To: Development Permit Panel

File: DP 18-829241

Re: Application by 1076694 BC Ltd. for a Development Permit at 10451, 10471 & 10491 No. 2 Road

PLAN 3F

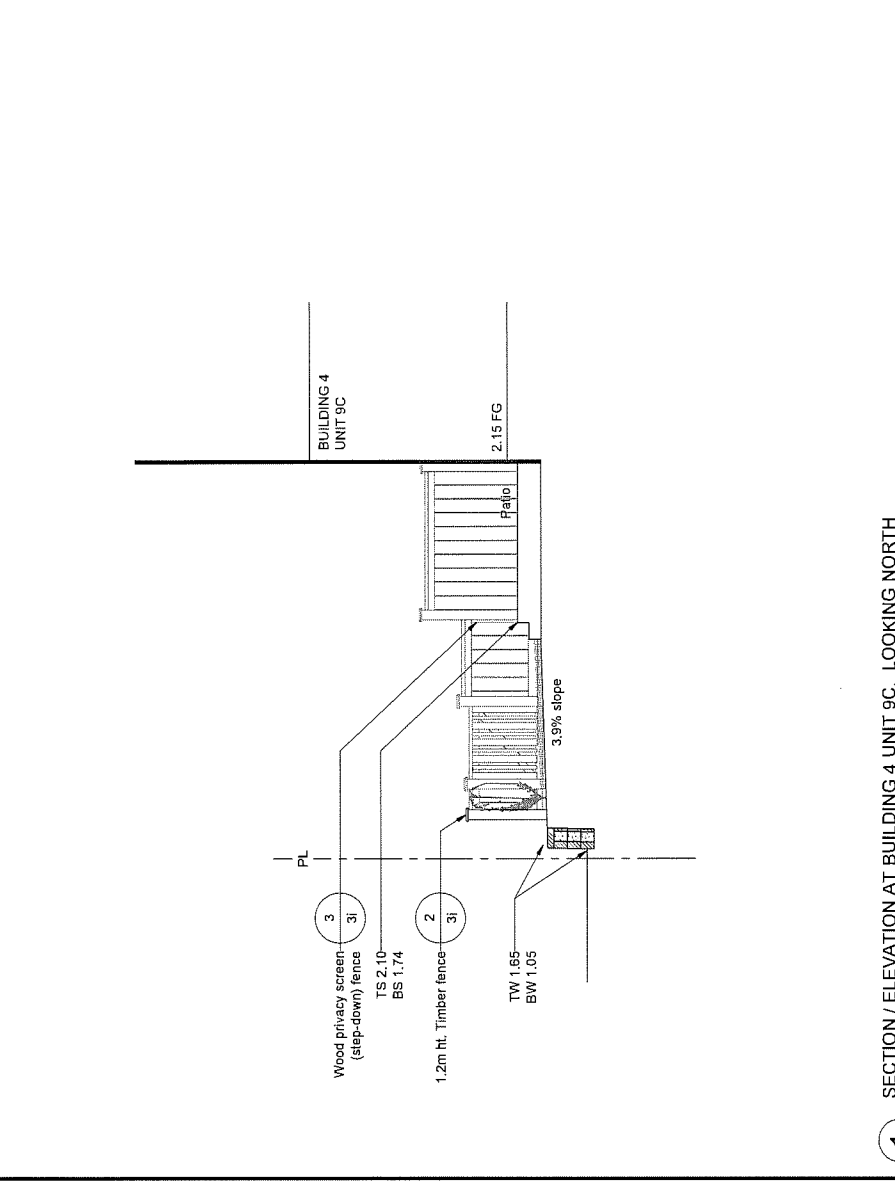
- consider eliminating the proposed play equipment and redesigning the play area using natural materials, e.g. logs and boulders, to provide more interest and play opportunities for children; would also be more economical to build;

- consider making the whole outdoor amenity area one level and using natural materials to enhance its usability and provide more play opportunities for children.

Previous play house has been eliminated as requested. A new playhouse has been added as requested. Topography proposes terraces, as with the previous concept. Refer to Section 3, sheet 3F. Amenity area re-designed as play space with seating.

This conflicts with a previous comment to 'take advantage of the topography'. We have not made the amenity area one level, as this makes the eastern portion of the amenity area ~ 3 feet lower than the sidewalk and the neighbouring site. Natural play elements have been added.

18-829241 DP AUG 06 2019 PLAN 3G

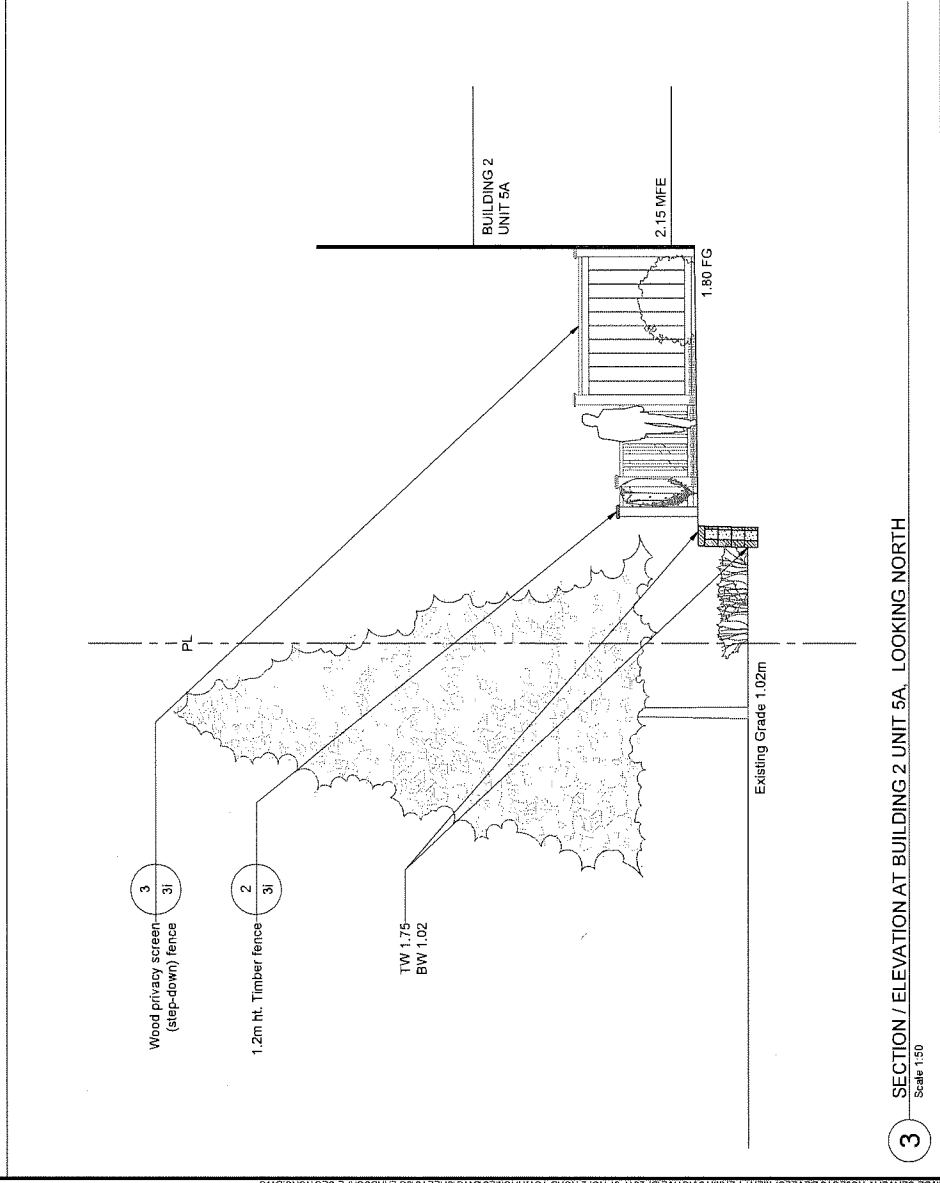
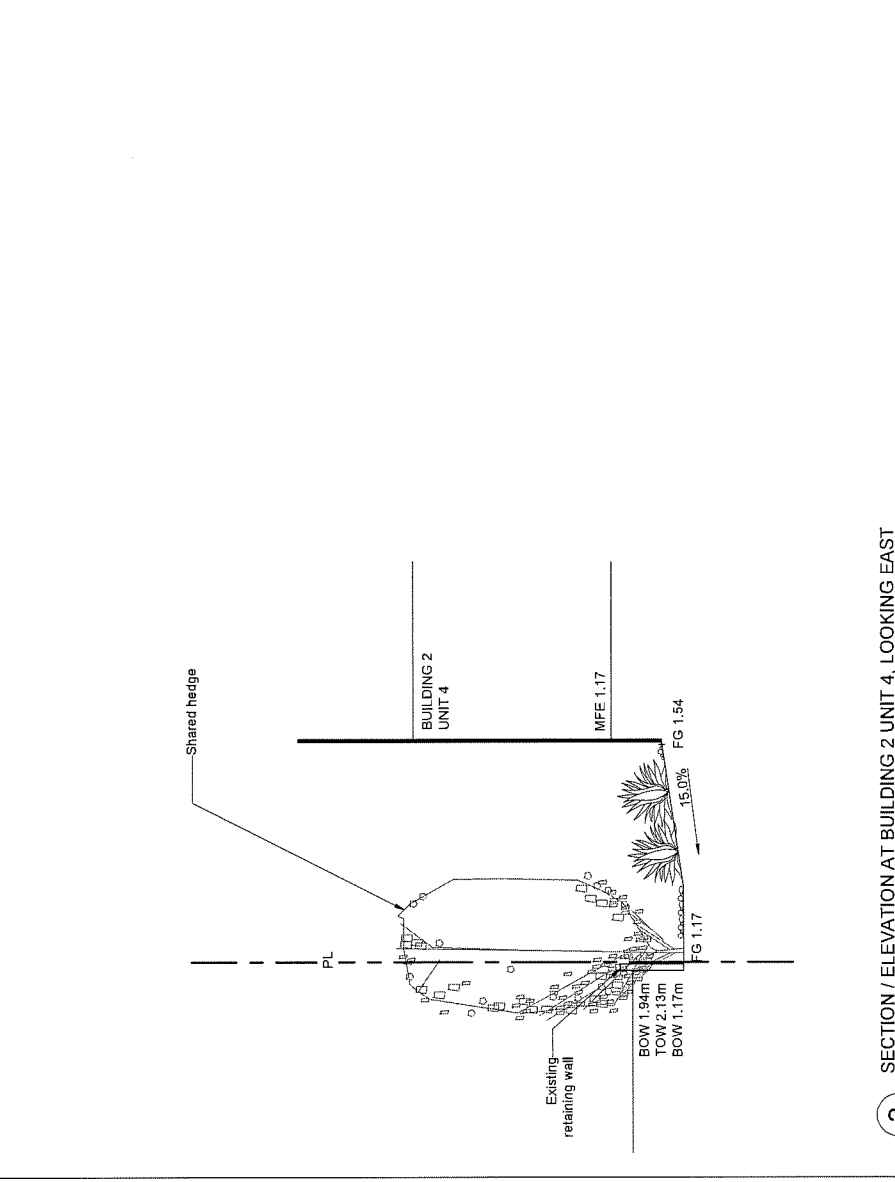
- Retaining walls will be provided along the west property line in order to provide usable yard space for the proposed units (ranging from 0.29 m to 0.87 m). A lower 1.2 m high timber

fence will be provided on top of the retaining wall to reduce the apparent height of the grade change, but also maintain privacy (cross-sections are provided in Plan #3.G).
